Change Log

TITLE: Serial Accelerometer Dongle v21		SFE
Document Number:		REV:
Date: 6/20/2011 11:59:24 AM		Sheet: 1/1

Accelerometer

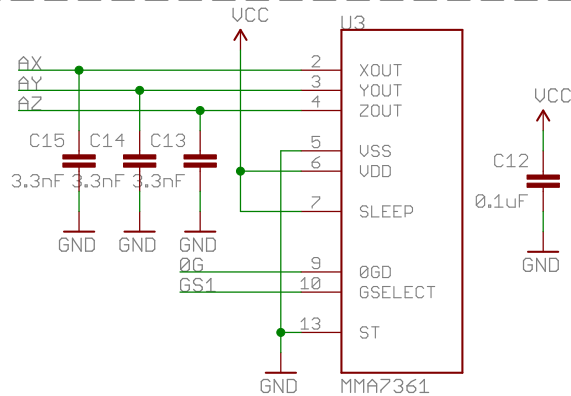
v21 Changes
 Update b511k to correct spelling
 Pulled Sleep Pin High
 Added indicator LEDs
 Added Øg interrupt pin
 Added Test Point to assist with test procedure
